UNITED STATES
DEPARTMENT OF THE INTERIOR
BUREAU OF LAND MANAGEMENTFORM APPROVED
OMB NO. 1004-0137
Expires: January 31, 2018**SUNDRY NOTICES AND REPORTS ON WELLS**
*Do not use this form for proposals to drill or to re-enter an abandoned well. Use form 3160-3 (APD) for such proposals.***SUBMIT IN TRIPLICATE - Other instructions on page 2**

EOG Resources requests an amendment to our approved APD for this well to reflect a change in BHL, TVD, and well number.

Revised Permit Information 05/22/18:

Well Name: Orrtanna 20 Fed No. 707H

Orrtanna 20 Fed #707H

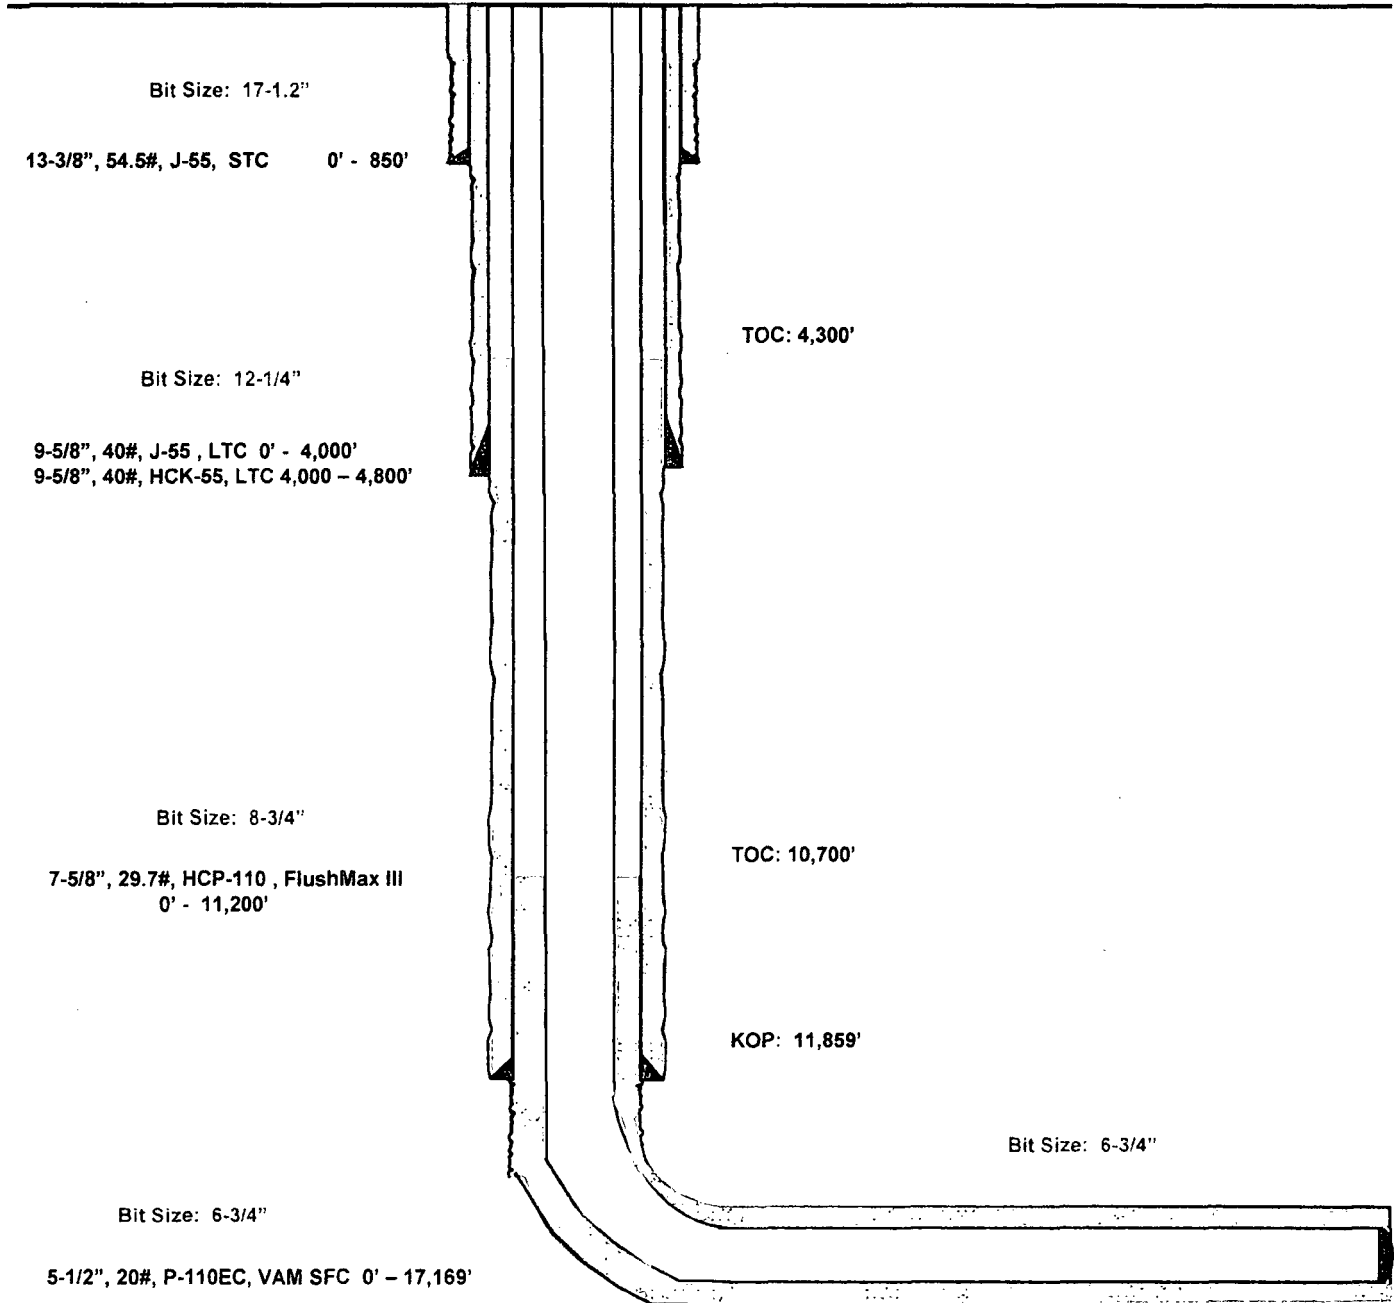
Change BHL to: 230' FNL & 830' FEL, 20-26S-33E Lea County
Change TVD and pool to: 12,340' TVD. Upper Wolfcamp
Change well name/number to Orttanna 20 Fed 707H.

Lateral: 17,169' MD, 12,340' TVD
Upper Most Perf:
330' FSL & 830' FEL Sec. 20
Lower Most Perf:
330' FNL & 830' FEL Sec. 20
BH Location: 230' FNL & 830' FEL
Section 20
T-26-S, R-33-E
